St. Anthony Airport Fire Pump Replacement – St. Anthony, NL

EC373-222510/A

AMENDMENT # 5

ADDENDUM NO. 3

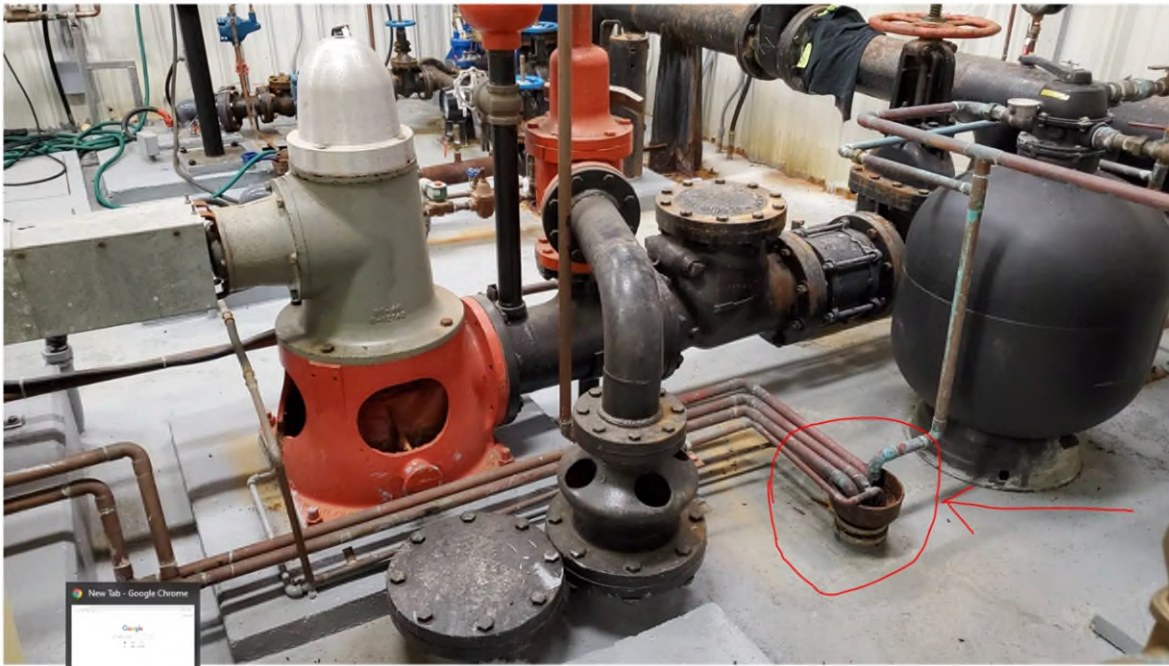
Question # 1: The controller is 9 years old. This is not going to work with a new engine, they will need to replace the controller as well. It's never generally a good idea to put a new engine with an old controller anyway. But they have no choice as the existing controller does not have the required terminals to pick up all the engine alarms.

Answer # 1: Controller to be reused – no change to the tender documents.
